RE: Ravensdown Ltd, APP-126684

Your letter dated 3 May 2022 requested further information under section 92 of the Resource Management Act 1991 ("RMA") in respect of the Ravensdown Ltd ("Ravensdown") applications for the various discharges permits and associated land use consents for the Awatoto site.

**Table 1: Ravensdown Resource Consent Application, Further Information Request Assessment Table**

Figure 1.1: Comparison of  $\text{SO}_2$  emission rates with the uncorrected and corrected gas flow rates for the period January 2016 to 1 August 2021.

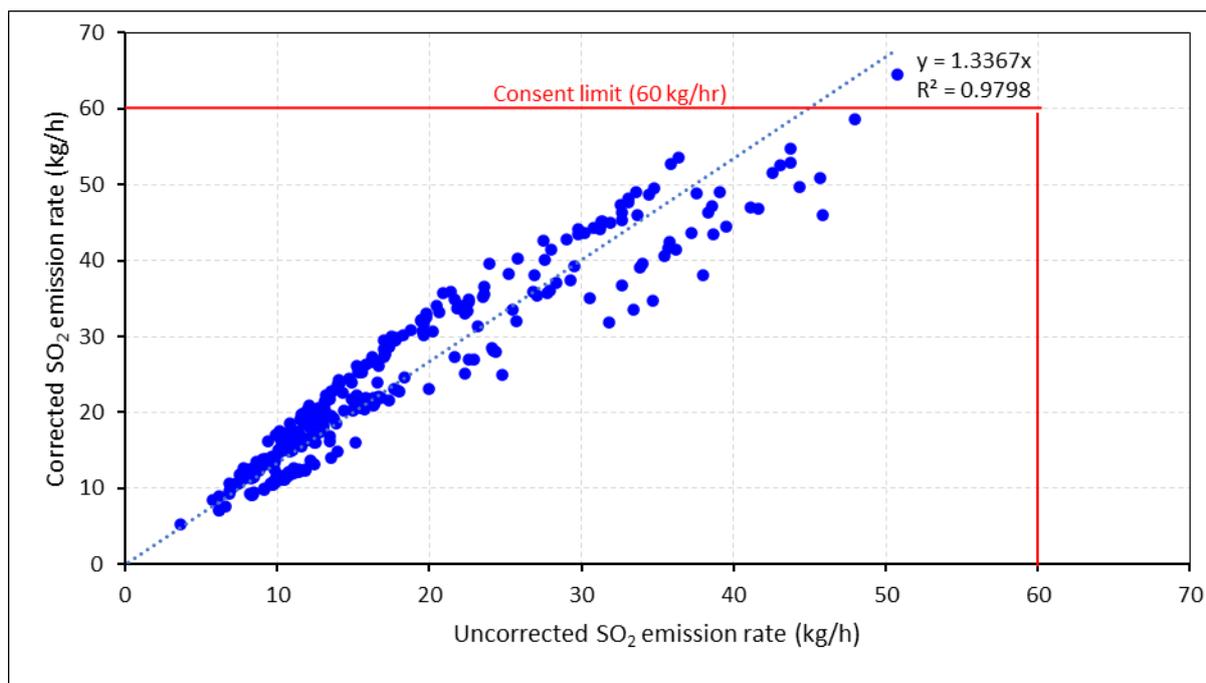
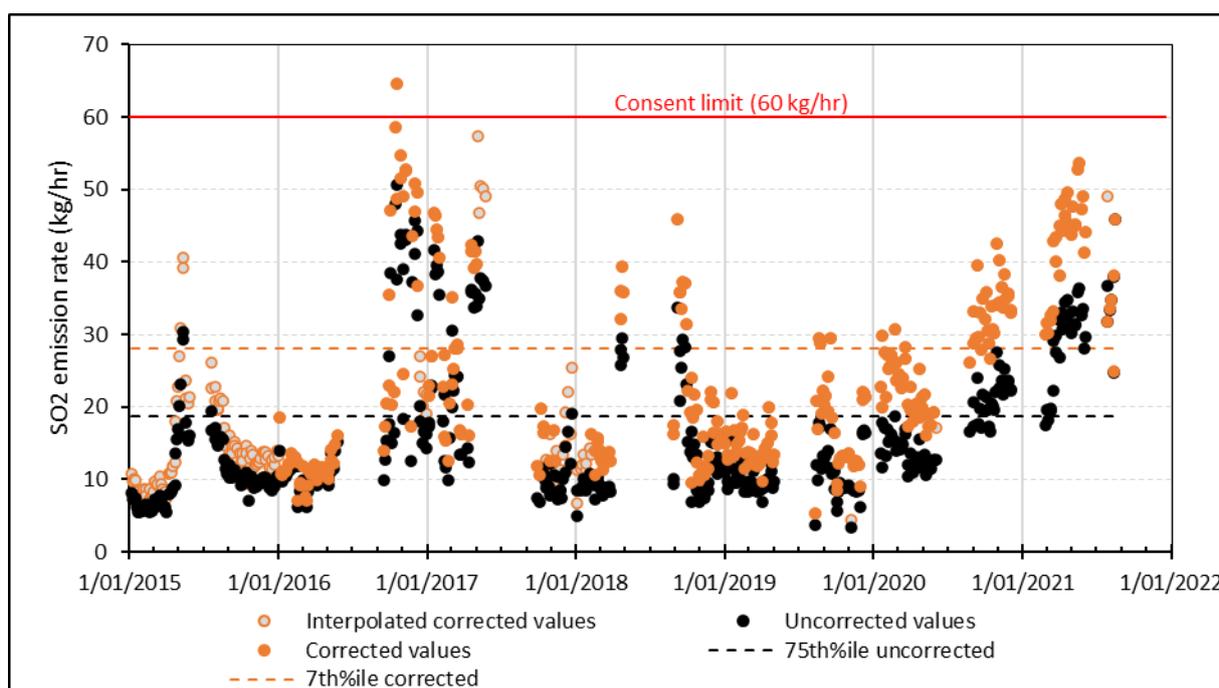
*1 Please provide further information on the issue with the acid plant discharge flowrates, including updated information identifying when the calibration issue occurred, and information to demonstrate whether emissions from the plant have been compliant with the limits in the resource consent.*

A comparison of the uncorrected and corrected SO<sub>2</sub> emission rates for the period from 2015 is presented in Figure 1.1 and Figure 1.2. This shows that the SO<sub>2</sub> emissions have complied with the limit of 60 kg/hr with the exception of a single result. Given this finding, and that no change is proposed to the emission rate limit of 60 kg/hr (until such time that the new converter is commissioned), the assessment against 1-hour and 24-hour assessment criteria presented in the T+T Air Quality Assessment remains appropriate.

Figure 1.1 provides an updated timeseries plot to that that given in the T+T Air Quality Assessment (Figure 3.2), that includes the corrected emission rates. Figure 1.1 also presents the 75<sup>th</sup> percentile values for the corrected and uncorrected SO<sub>2</sub> emission rates, which shows an increase from 18.7 kg/hr to 28.1 kg/hr. This revised value of 28.1 kg/hr has been used in an updated dispersion modelling assessment to predict annual average SO<sub>2</sub> ground level concentrations, as discussed in section 4 below.

Figure 4.1: Analysis of measured 1-hour average SO<sub>2</sub> concentrations by wind direction that associated with normal Acid Plant start-up. Values represent concentrations measured in the preceding 5 days prior to sulphur being introduced into the burner.

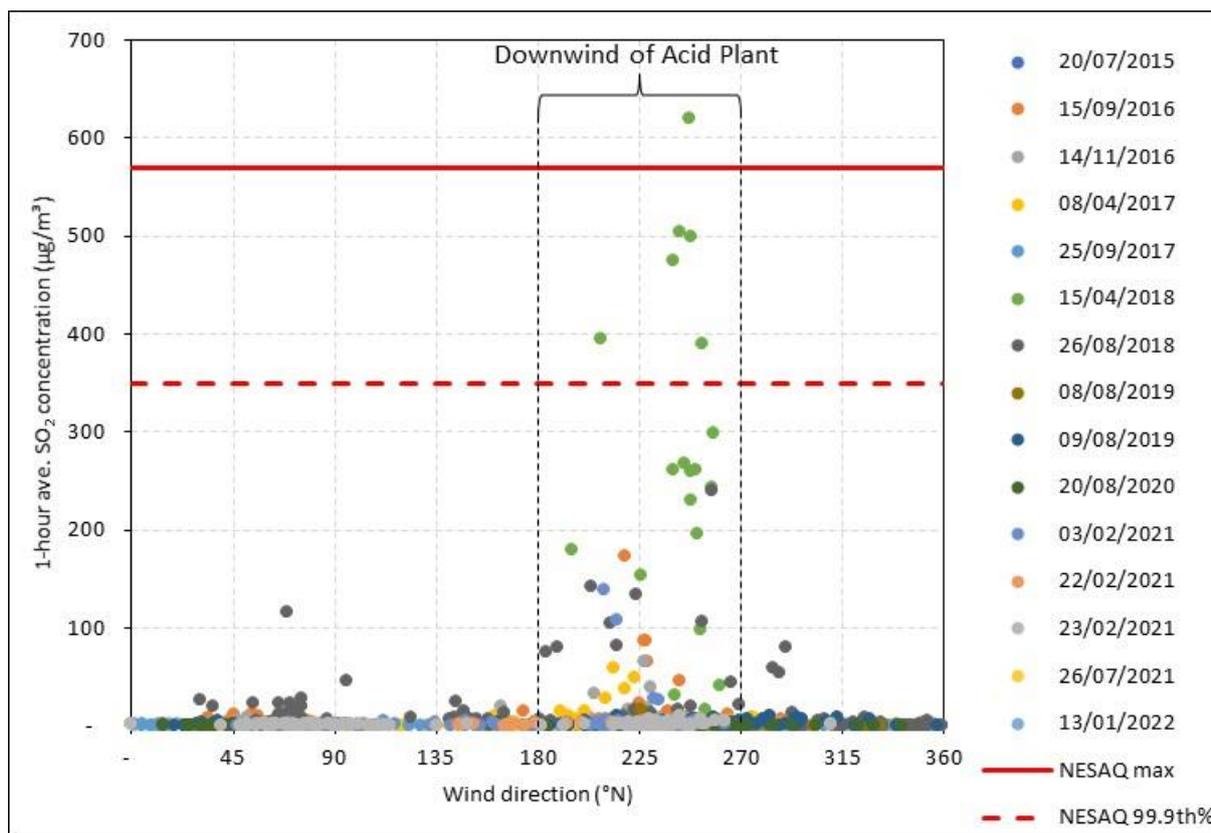
*4. Please update the section on ambient monitoring of sulphur dioxide to clearly demonstrate the contribution from normal acid plant start-ups.*

The measured SO<sub>2</sub> concentration during each start up period by wind direction is summarised in Figure 4.1. This analysis clearly highlights the period of high concentrations that occurred on 11 April 2018 during a start-up, which is discussed in Section 5.3 of the T+T Air Quality Assessment. As noted in the report, the cause of this issue was identified as being due to the then use of a 3 m high temporary stack that was fixed to the furnace during pre-heating of the furnace. This was addressed by the installation of a permanent 13 m high stack during the 2018 winter shutdown. Other protocols associated with both plant shut-down and start-up have also been implemented. Concentrations during start-up have been significantly lower since these measures were implemented.

This analysis demonstrates that Acid Plant start-ups have not been responsible for peak concentrations of SO<sub>2</sub> measured at the former Winstone monitoring site since the measures implemented during the 2018 winter shutdown period.

Figure 2. The Awatoto SPZ map showing the Project Area and proposed Land Discharge area (source: HBRC, Ravensdown).

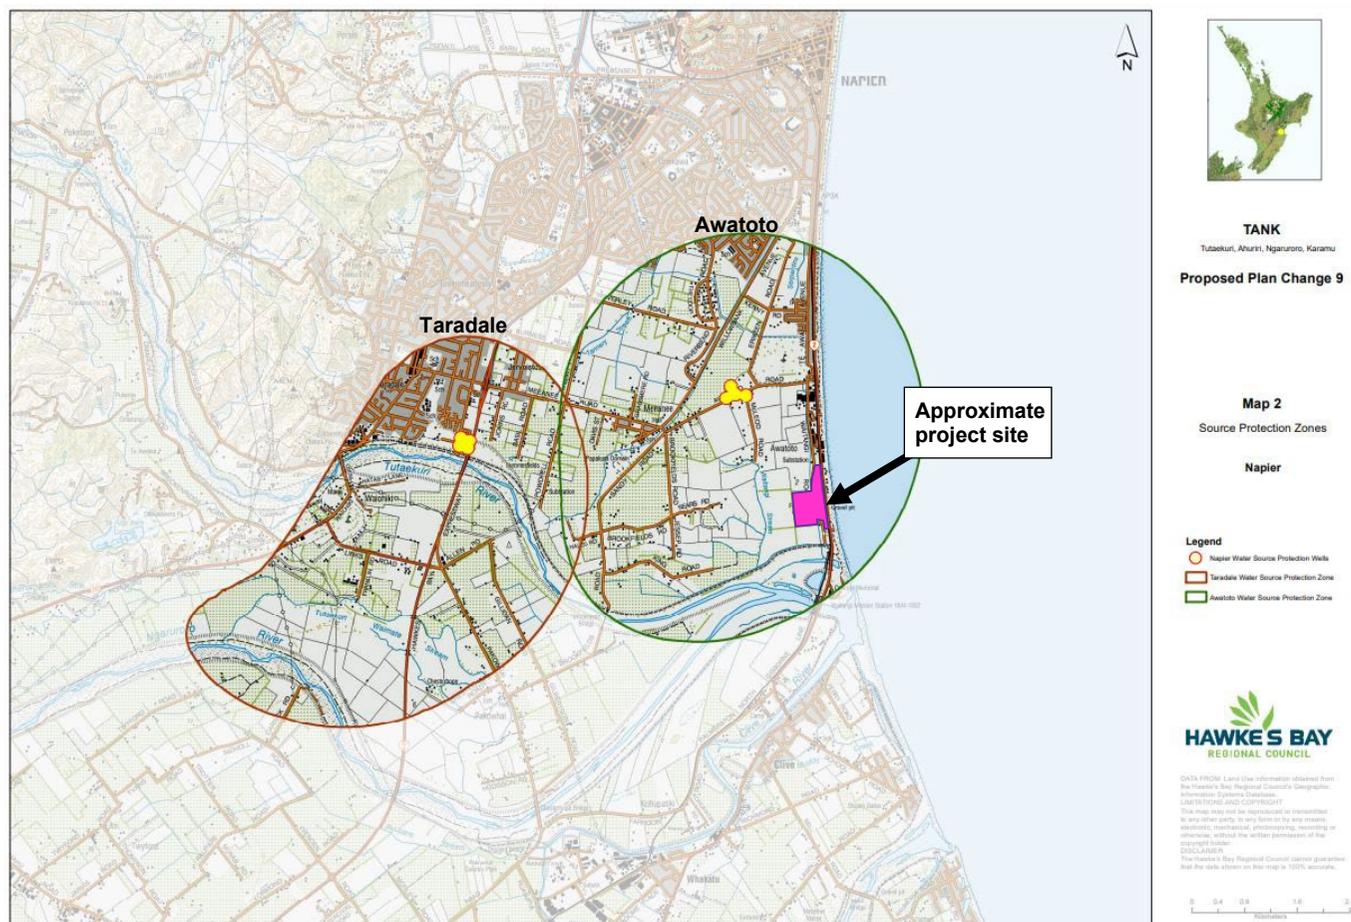
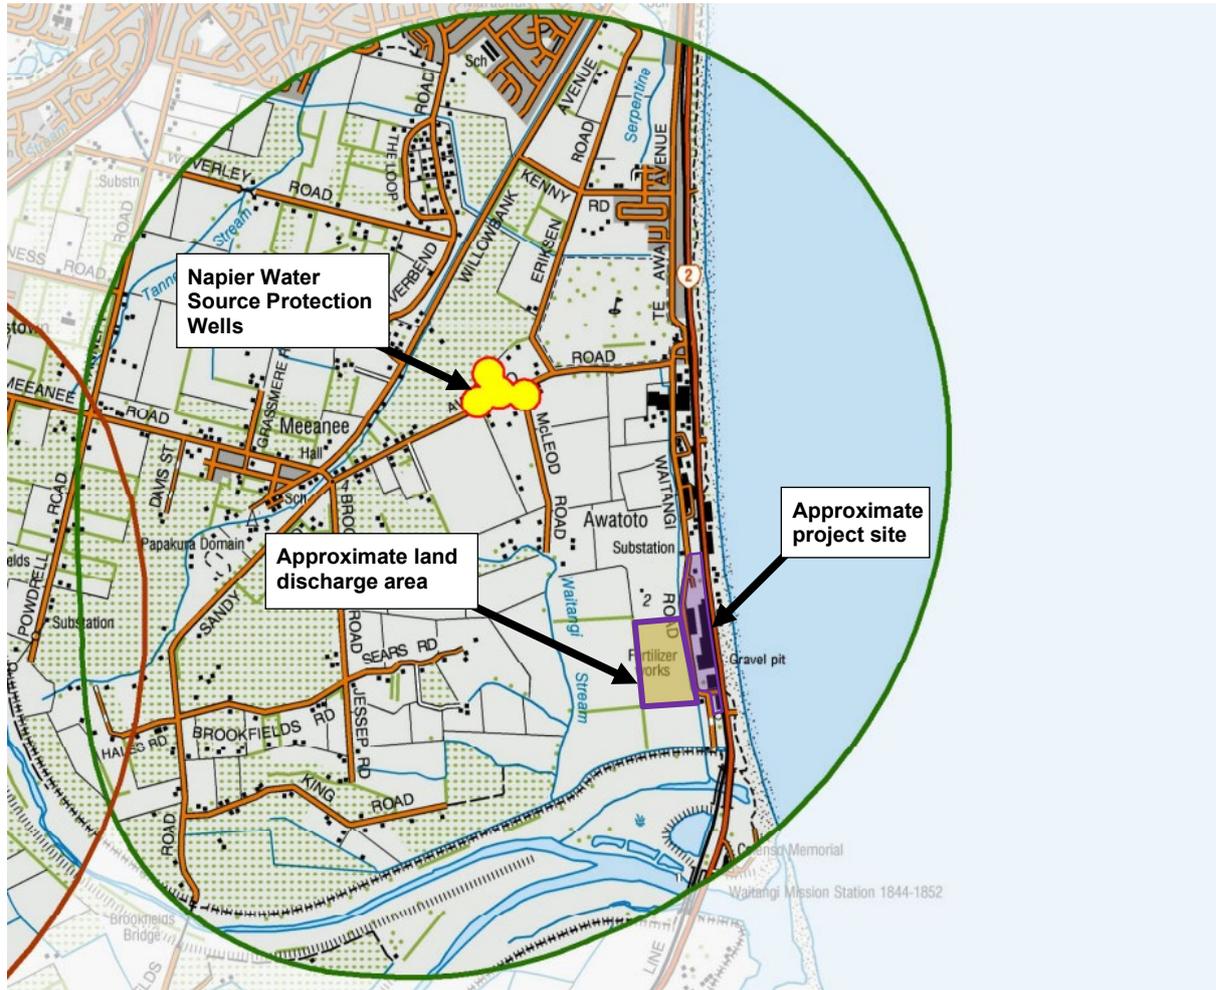
- 34. Provide a map of the SPZs with the full site boundary including the land discharge area. The names of the SPZs and distances from or if the site is included within a SPZ should be provided in the Appendix and where relevant in existing text that refer to the SPZ, notably the Executive Summary.*
- 35. Please consider and provide commentary on the revised well locations (refer Figure 10 below with recommended locations) and increase the number of sampled monitoring wells to all three wells.*

The map displayed in Figure 2 shows the Awatoto SPZ along with the Project Site boundaries and land discharge area which lies toward the southeast of the zone.

Figure 3. Proposed Monitor Well Locations as suggested by Mott McDonald.

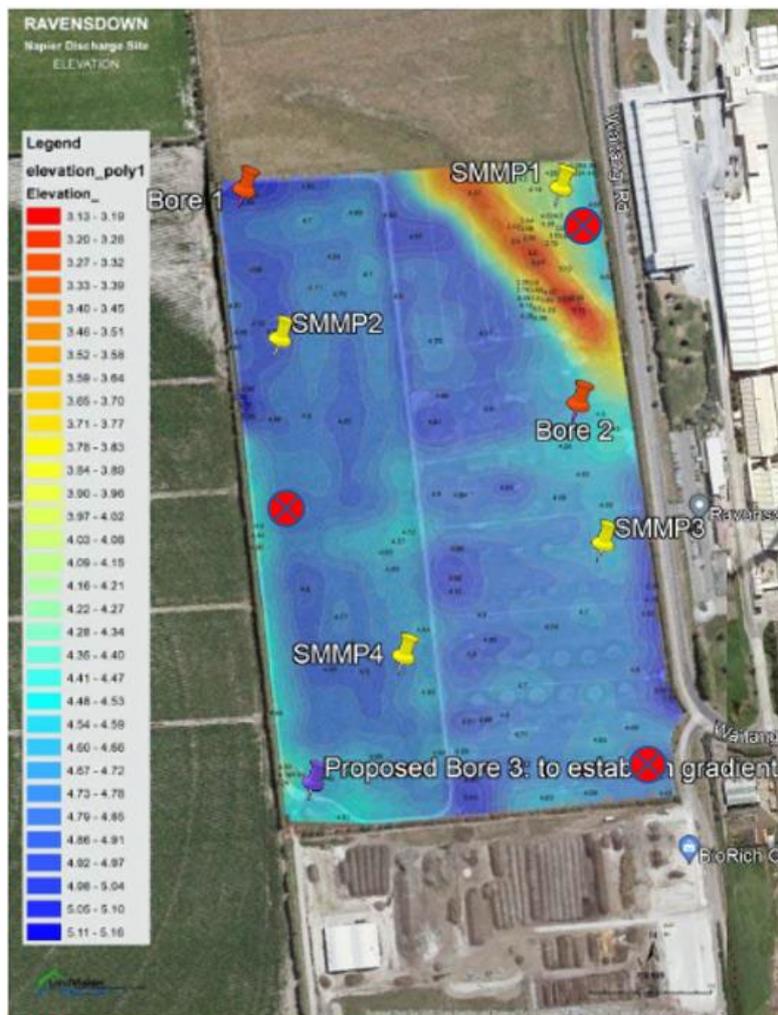
35.	Please consider and provide commentary on the revised well locations (refer Figure 10 below with recommended locations) and increase the number of sampled monitoring wells to all three wells.	Attachment 7 - Bay Geological Services Ltd, 20 April 2022

The technical reviewers assessed the intended locations of planned shallow Monitor Bores located across the planned land discharge, and suggested an additional Monitor Bore and alternative locations for two monitoring bores. The addition of a third shallow monitoring bore serves to increase opportunities to both intercept potential contaminants and also provide a hydraulically upgradient sampling site from which to obtain a baseline.

However, as indicated in the Hydrogeological Assessment (Bay Geological Services Ltd, 2021), the hydraulic gradient of the near-surface groundwater is unknown, but is predicted to be influenced by topography rather than reflect the hydraulic gradient of the deeper (>50 m below ground level (bgl)) aquifer. The Hydrogeological Assessment proposed that three monitor bores be drilled across the site to map groundwater contours in the unconfined aquifer and establish the groundwater flow direction in conjunction with water level data from the BioRich monitor bores.
